MARINO ENGINEERING ASSOCIATES, INC.

April 15, 2020

Re: Review of Brook Mine Application – Rounds 8 to 12

FIGURE 4.4 PROPOSED HIGHWALL MINING AND PILLAR CONFIGURATION (SEE P. MP-F3)

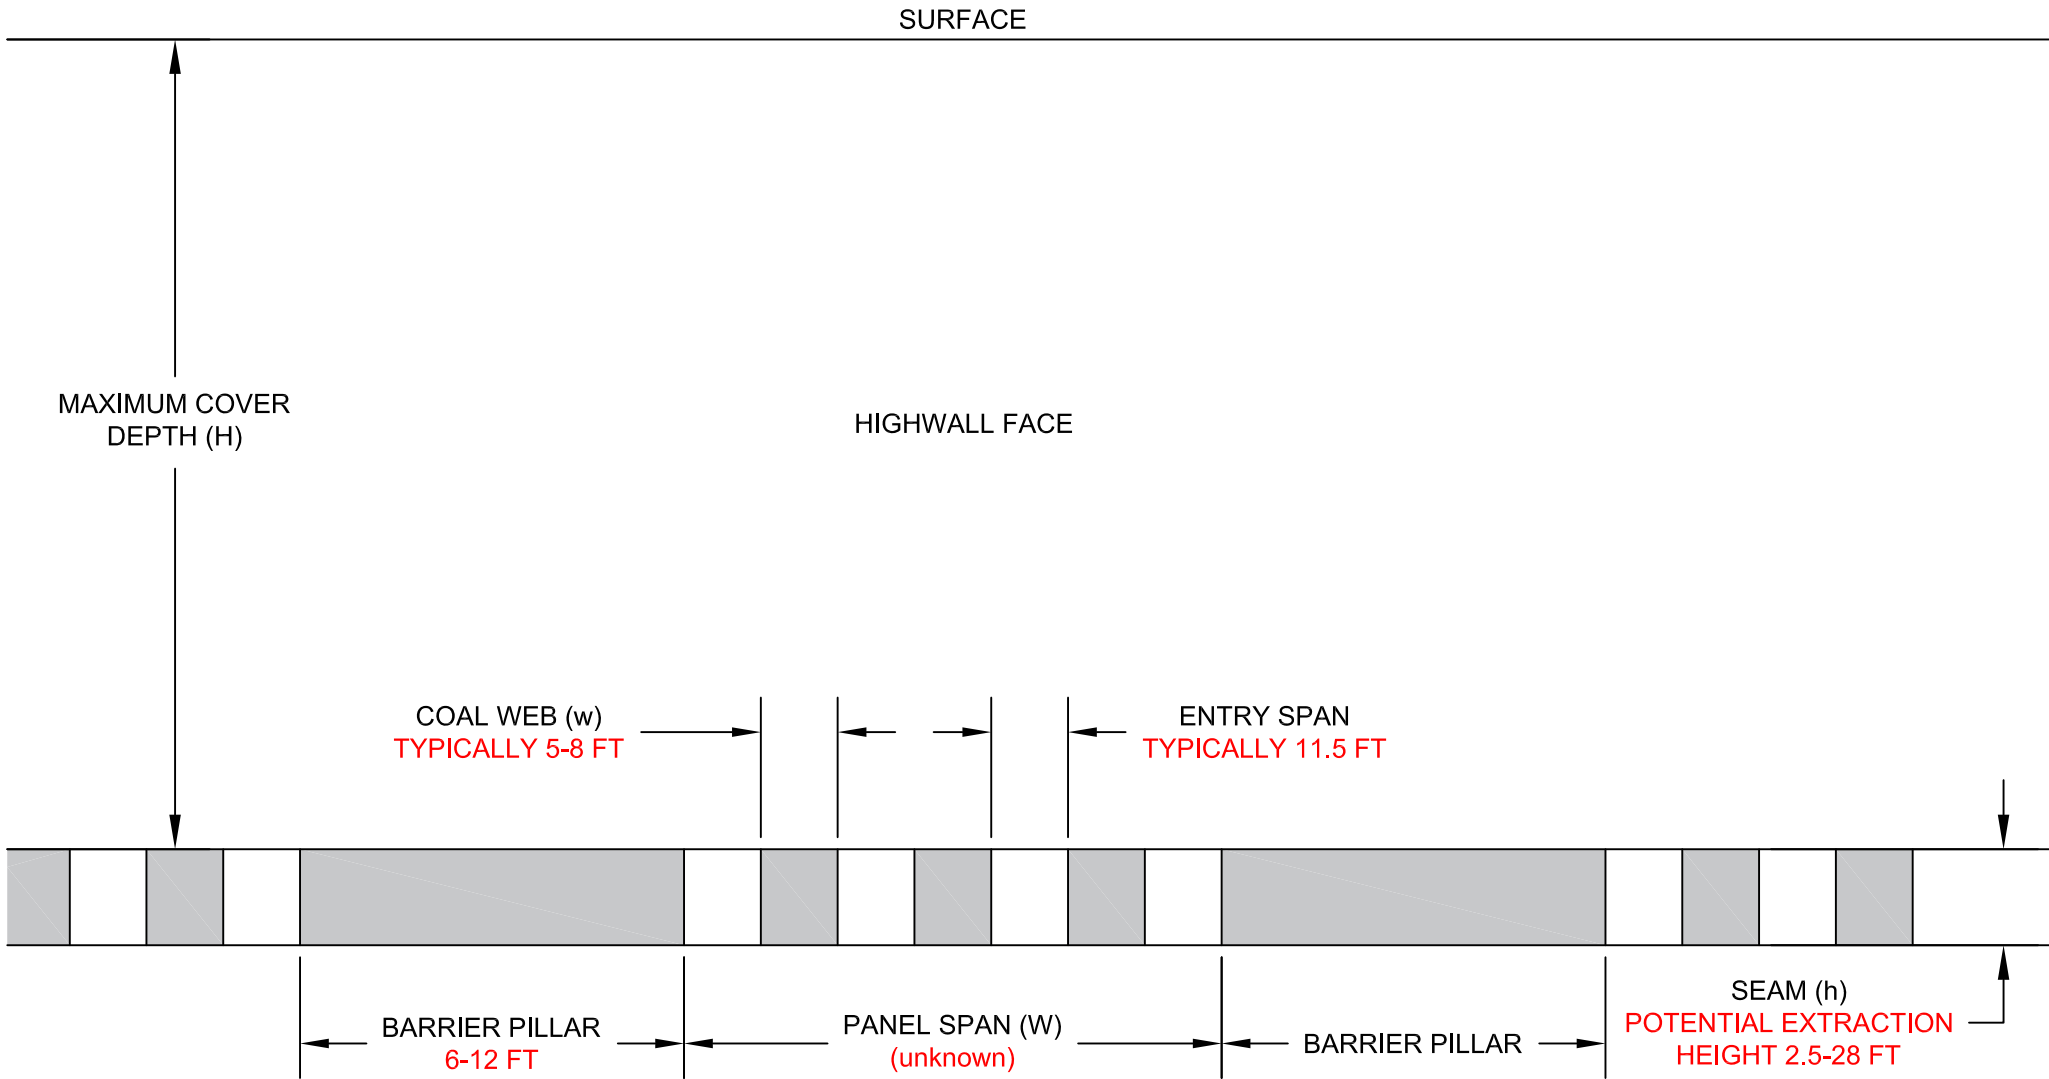
The proposed room and pillar configuration is depicted in Figure 4.4. As can be seen in Figure 4.4, there is no definitive geometry stipulated in the application as much of the identified dimensions are qualified. Using the “typical” web pillar widths and room width, the panel extraction ratio would vary from 59% to 70% in the panels.
